# Mimico Creek Restoration and Water Infrastructure Protection Study

## Public Consultation Report September 2024

#### Do you have specific comments about any of the recommended projects?

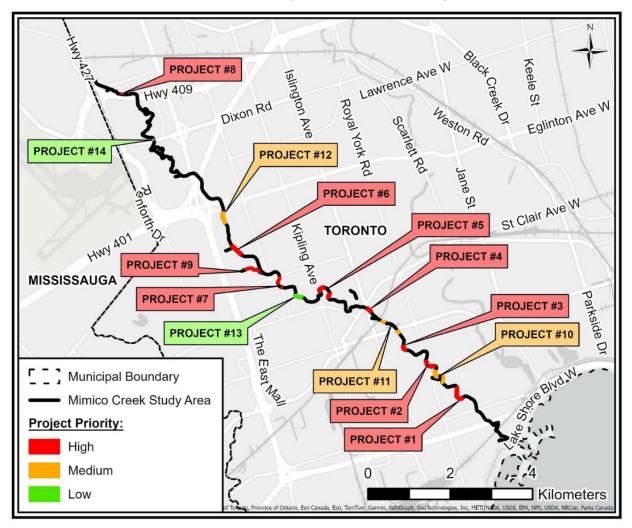
| Project # and<br>recommended scope of<br>work | Comments   |
|---|--|
| <b>#1</b><br>Sub-reach work                   | There is support for recommended project work and<br>prioritisation based on project numbering   |
| approximately 390 metres                      | Current observations include erosion and dead vegetation   |
|   | <ul> <li>Moonseed vine has been identified in the area</li> </ul>  |
|   | Suggestion to plant native species to assist with erosion  |
| #2  | There is support for recommended project work  |
| Sub-reach works<br>approximately 300 metres   | <ul> <li>Storm sewers and covers need to be maintained and<br/>made more functional</li> </ul>   |
| #3  | There is support for recommended project work  |
| Sub-reach works approximately 170 metres      | • There is an interest in ensuring spawning fish can migrate upstream  |
|   | <ul> <li>Suggested method of improvement should include<br/>dredging the area (remove the sediment from the creek<br/>bed)</li> </ul>  |
| #4  | There is support for recommended project work  |
| Sub-reach works approximately 150 metres      | There were questions about potential impacts on the<br>Montgomery Inn and the Islington Golf Club  |
|   | • Current observations of the area include silt at the bridge under the Islington / Dundas intersection, erosion downstream and storm drains eroded at their footings                                    |
|   | <ul> <li>A question was asked about the (abandoned) watermain<br/>under the bridge</li> </ul>  |
|   | Construction related concerns include potential impacts     on traffic at Dundas Street and Islington Avenue   |
| #5  | There is support for recommended project work  |
| Sub-reach works approximately 350 metres      | There were questions about potential impacts to the<br>Islington Golf Club   |
|   | • Concern for current conditions include erosion around the area of Echo Valley Park, ice jams in the winter and water in backyards as part of floodplain flows seasonally or in response to heavy rains |
|   | A suggestion was made to plant more stable vegetation<br>and stones to assist with erosion control   |
| #6  | There is support for recommended project work  |
| Sub-reach works                               | Current observations of the area include owl habitat   |
| approximately 350 metres                      | Continued observation of the creek walls and storm sewer outfall grates is needed to ensure efficient water flow   |

| #7   | There is support for recommended project work   |
|--|---|
| Local works approximately 40 metres  | Drains in the area need to be maintained and improved<br>for water flow   |
| #8   | There is support for recommended project work   |
| Local works approximately 20 metres  | There is a concern for pollution entering the creek from<br>local factories and businesses  |
| Sub-reach works  | Current observations of the area include owl habitat  |
| approximately 370 metres   | • There is concern for the storm sewer outfall south of the West Dean Park bridge where there is erosion, material debris and a tree blockage                                 |
| Sub-reach works  | Current observations of the area include owl habitat  |
| approximately 375 metres   | • Concern for current conditions include the impact of backfill on the concrete channel and erosion at the bend combined along with debris downstream and a large fallen tree |
|  | <ul> <li>Suggestion for native trees and bushes to be planted in this area</li> </ul>   |
| Local works approximately<br>70 metres along the creek<br>with approximately 90 metres<br>of bank work | <ul> <li>Concern for the high creek flow when it rains and<br/>vandalism of the vegetation on city land</li> </ul>  |
